Sub: Proposal for diversion of 250.08 ha. of forest land in favour of Andhra Pradesh Capital Region Development Authority (APCRDA) for establishment Forest Academy, IIF&CC, APFD, APFDC, APPCB and NGC under Capital City Infrastructure Development Projects in Kondaveedu Block, Guntur Division and District Andhra Pradesh (Online Proposal No. FP/AP/Others/30168/2017) Reg.

FACT SHEET

9. Concept plan furnished in the proposal:

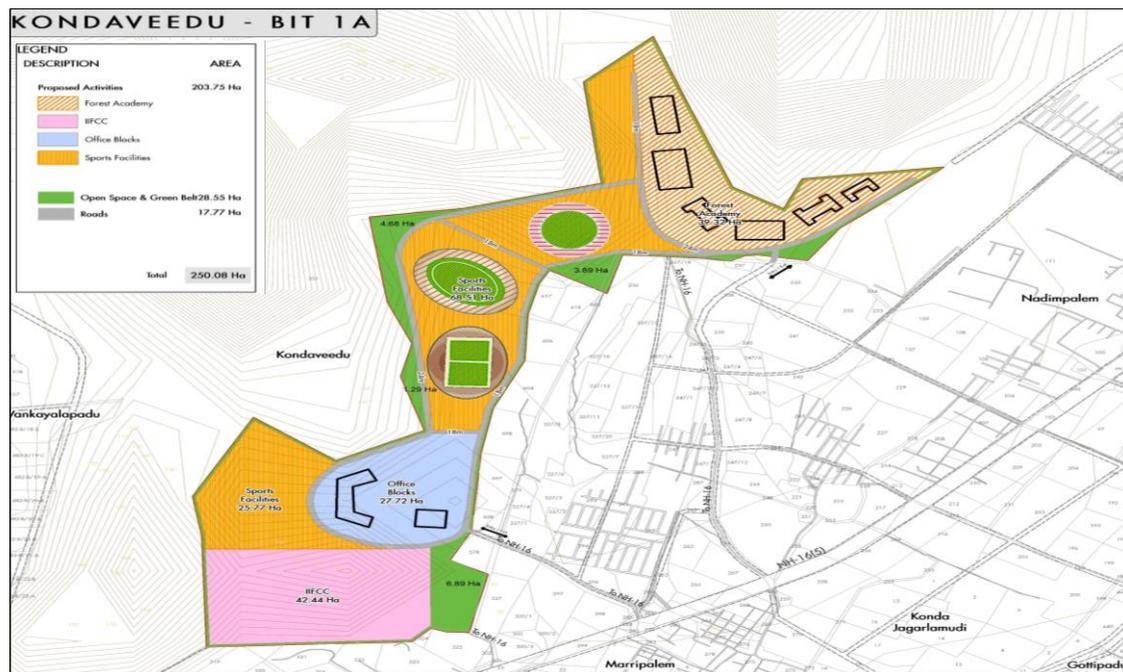
- 10.3** The User Agency has provided breakup of the forest area proposed for diversion in a broad thematic manner and indicated the overall quantum of open spaces and green areas in percentage terms. However, the proposal does not have finer details/break-up of the intended final certified land use and it is silent on the quantum of hill cutting involved in its execution. For example, an area of 39.31 ha area is proposed for 'Forest Academy' but no further details of sub-components have been provided, including corresponding open spaces.

- 10.4** In the proposal, no area has been earmarked for 'Utilities' as in other proposals.
- 10.5** During discussions with the User Agency, it emerged that the land use planning process for the proposed area has not been finalized yet and the sub component wise details, etc will be worked out only in future, which means the requirements indicated in the current proposal may be subject to change. It is also learnt from the AP Forest Department officials that the Department has recently requested the State Government to revise the requirement of forest land for the said 'Forest Academy' from 39.31 ha to 100 ha on which the decision of the State Government is awaited. In short, the land use planning for the area sought to be diverted has not been frozen yet.

- 11.2** As per the layout plan furnished by the User Agency, establishment of infrastructure for the IIF&CC has been proposed at a site where a hillock of huge sheet rock stands now. Similarly, as per the layout plan, sports facilities and the Forest academy are also falling on rocky hillock portions requiring huge hill cutting. However the proposal is silent on the requirement of cutting the hill. The User Agency has not provided any information on the actual area which requires hill cutting/quarrying and the quantum of materials expected to be extracted. The provisions of the Mines and Minerals (Development and Regulation) amendment Act, 2015, or Rules framed there under will have to be adhered to by the User Agency in respect of the mining/quarrying component.

- 12.1** The proposal is non-site specific and in its present form involves construction of some of the proposed infrastructures on the hill slopes, which is expected to require hill cutting. The proposal does not have finer details/break-up of the intended final certified land use and it is silent on the quantum of hill cutting involved in its execution. It is learnt from the User Agency that as per the project design, various project components will have to be executed by different agencies / departments. This will amount to transfer / sublet the diverted forest area, for which prior approval of the GoI is required in each case. Hence, **consideration of this proposal may require making enabling modifications in the existing FC guidelines in the first place if deemed fit**, which needs to be decided by the competent authority.

- 12.3** If the proposal is taken up for further consideration, since the forest area required for the project does not appear to be the barest minimum, the User Agency may be directed to rationalize the actual area required by leaving out the rocky areas requiring huge hill cutting and also the areas proposed for residential accommodations, hostels and commercial buildings. The infrastructures for residential, commercial buildings, hostels, dormitories, etc shall be shifted to outside the forest area and the layout plan needs to be changed accordingly.

- 12.3.1** The State Government may be asked to submit a revised layout plan on a digital elevation platform depicting all component land uses and open/green spaces along with a detailed report on the quantum of stone materials to be extracted for execution of the project; The provisions of the Mines and Minerals (Development and Regulation) amendment Act, 2015, or Rules framed there under will have to be adhered to by the User Agency in respect of the mining/quarrying component.

- 12.3.2** For each of the thematic zones proposed, the final certified land use indicating further breakup of the forest land required, sub-component wise and clearly depicting the area to be kept as open space and green areas under each component may be sought for from the State Government, unless the requirement is relaxed by the competent authority.
